Village of Thiensville
Plan Commission
AGENDA

DATE: Tuesday, June 11, 2024

**GILMAN
413 OAKWOOD
BACKYARD SHED**

To: Thiensville Plan Commission

FIRST FLOOR PLAN
1/4"=1'-0"

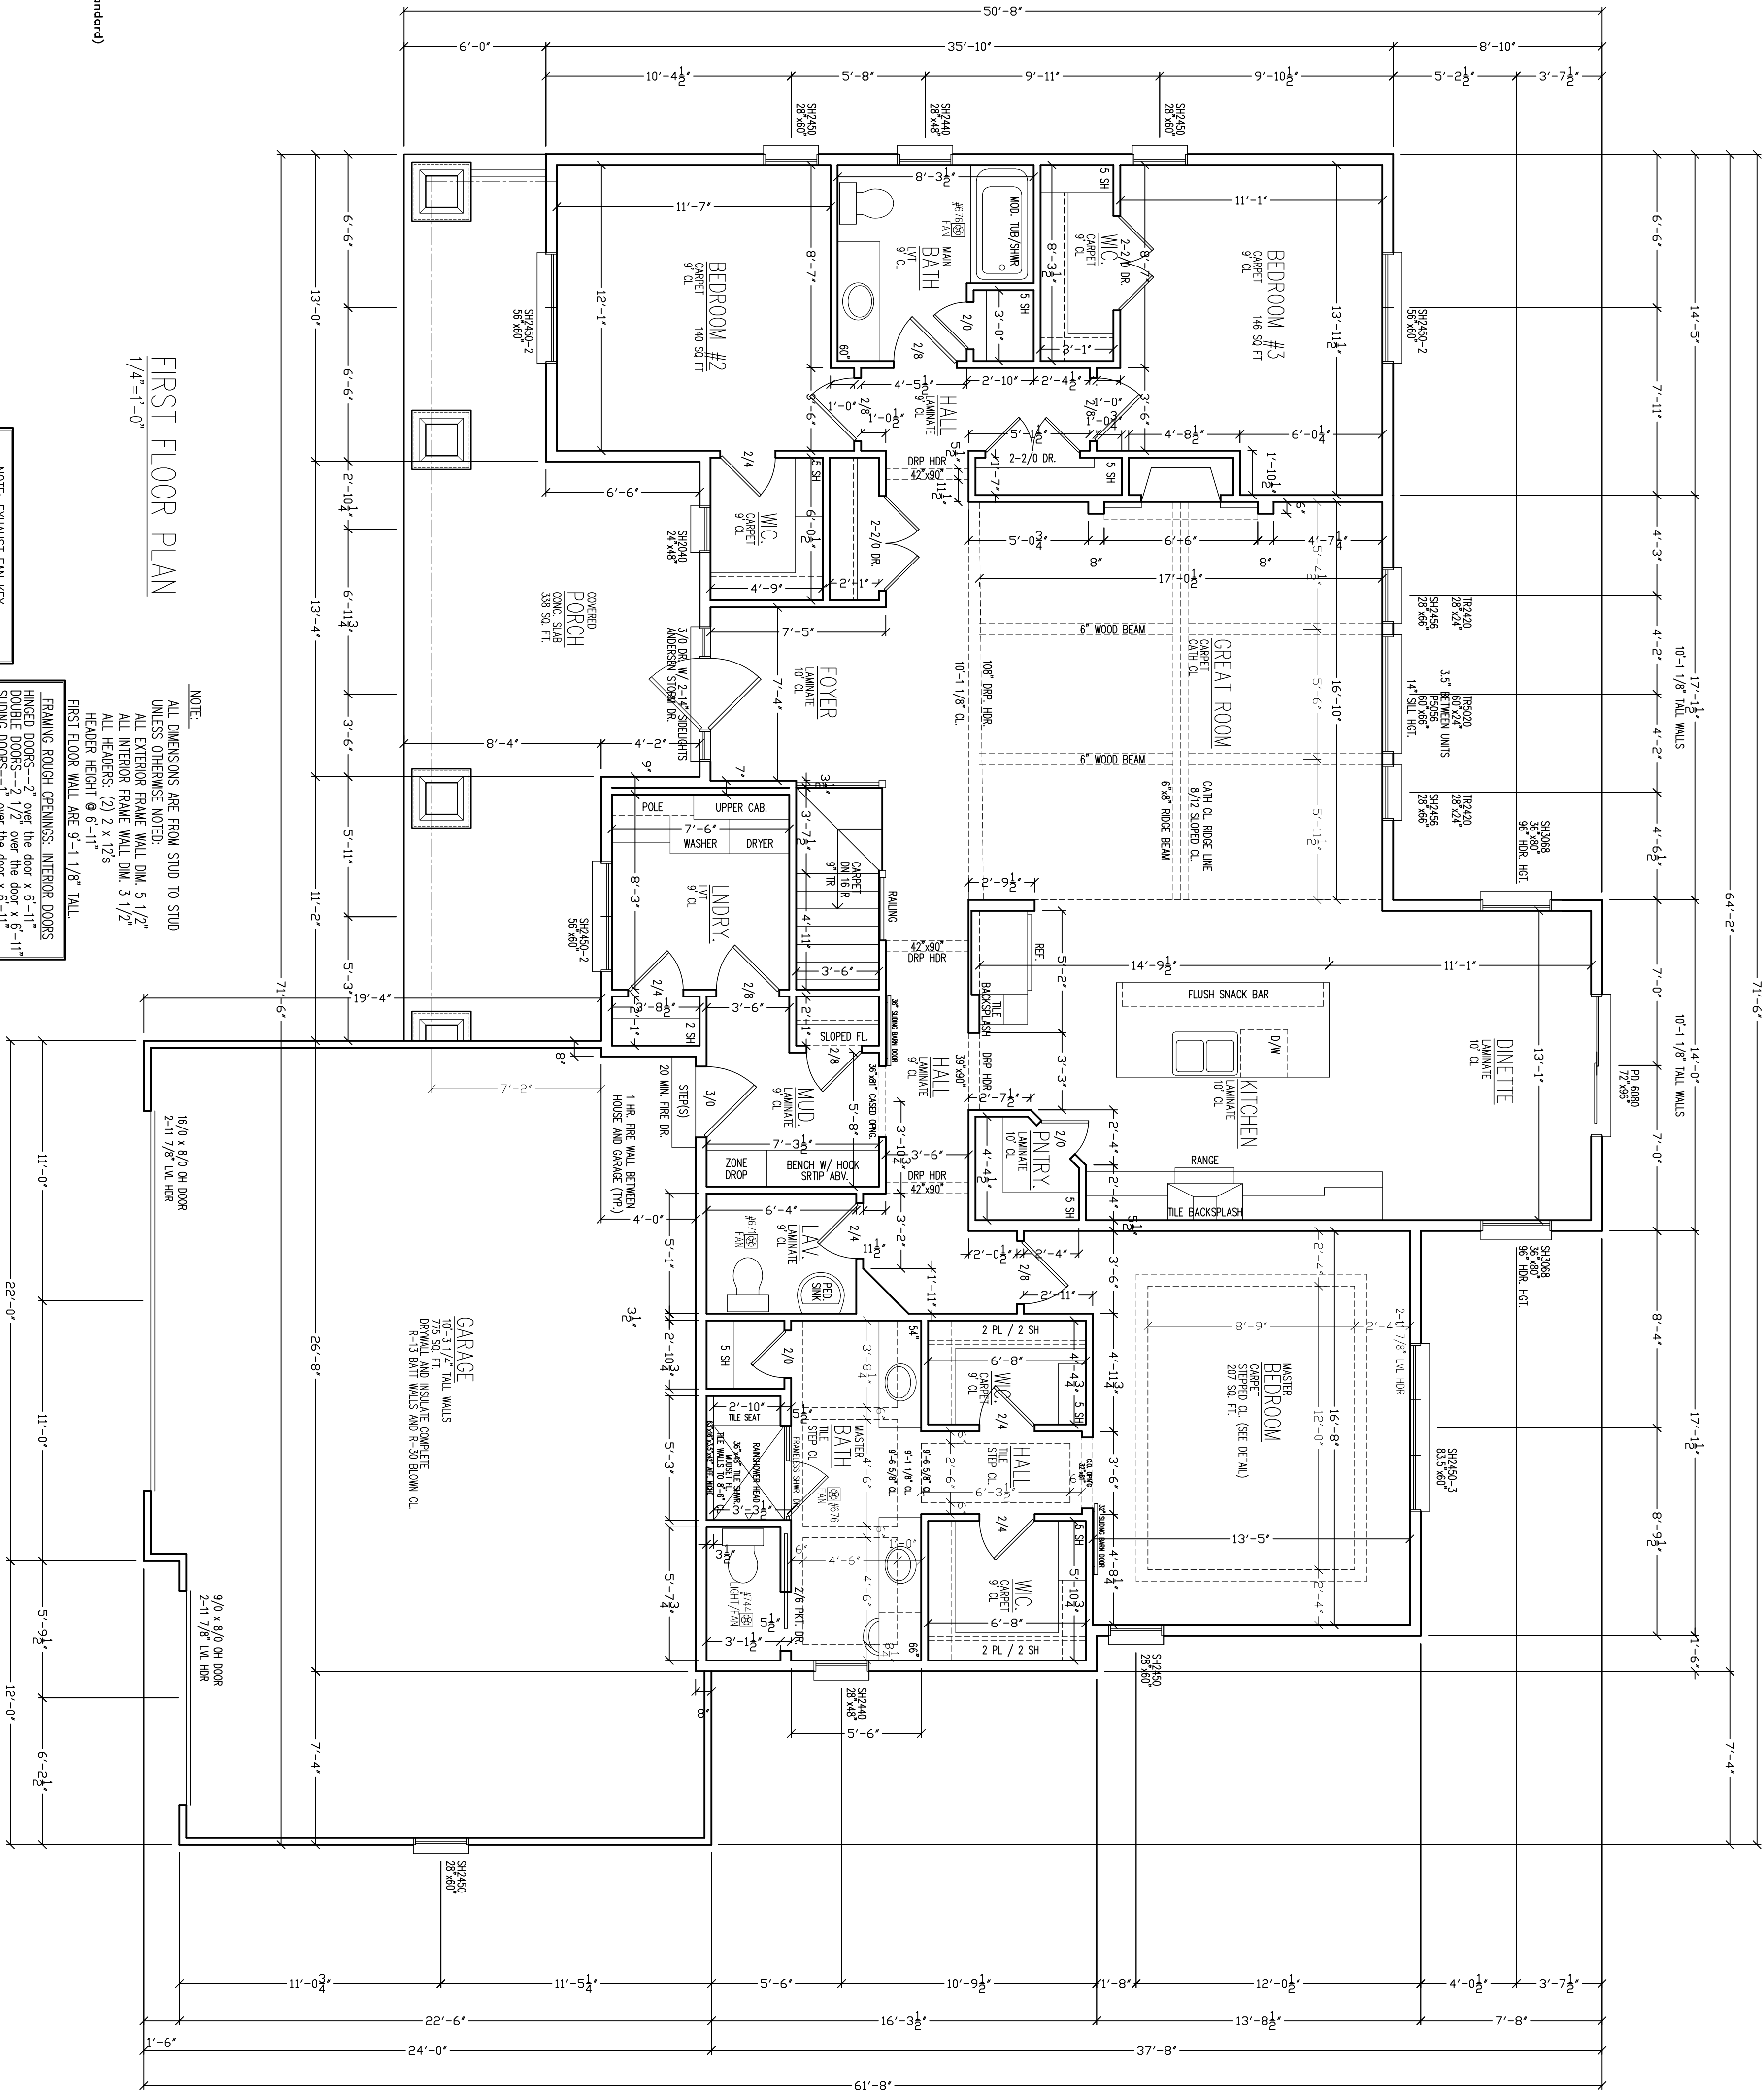
The applicant is requesting approval of house plans for a single-family home designed to look like a modern farmhouse for the currently vacant lot at 624 Green Bay Road. These plans propose a 3,290 square foot house that meets and exceeds the setback requirements of the R-1 District. The table below compares the R-1 zoning districts yard and height requirements and the plan's proposed dimensions.

Yard/Height Requirement	R-1 Standard	Project Plan
Minimum Building Area	1,200 sf	3,290 sf
Minimum Front Setback	40 ft	50 ft
Minimum Side Yard	10 ft	11.7 ft
Minimum Rear Yard	25 ft	80.9 ft
Maximum Building Height	35 ft	27.1 ft
Total Lot Area	13,500 sf	1,9121 sf

The submitted elevations and building plans show a three-car garage, with a double and single garage door, facing front toward Green Bay Road. The driveway will provide street access and is designed within the side setbacks as required by the code.

The plans show an attractive home single-story home with a basement and a covered front porch with a mix of building materials and colors that will be compatible but not repetitive of surrounding homes. Building materials include vertical board and batten siding, traditional cement board siding, stone, and

wood with enamel roofing covering the porch area. The home generally meets the single-family residential architectural review guidelines, however, the front facing garage is somewhat contrary to the guideline that, *“(5) New housing development shall avoid front elevations, which mainly consist of rows of garage doors.”* While many older homes along Green Bay Road have front facing garages, many of the newer residential developed homes include side facing garages. It is to the Plan Commission’s interpretation and discretion to approve the plan as designed with the front facing garage.

Landscaping plans were not included with this application. It appears that the home is being built prior to securing a buyer/occupier who may have input on the landscaping of the project. The report will recommend that a landscape plan, as required by the code, is provided prior to the project’s occupancy.

- Director of Public Works review and approval of the grading, drainage and erosion control plans.
- Provision of an approved landscape plan prior to occupancy.
- The applicant secures a building permit prior to construction commencement.
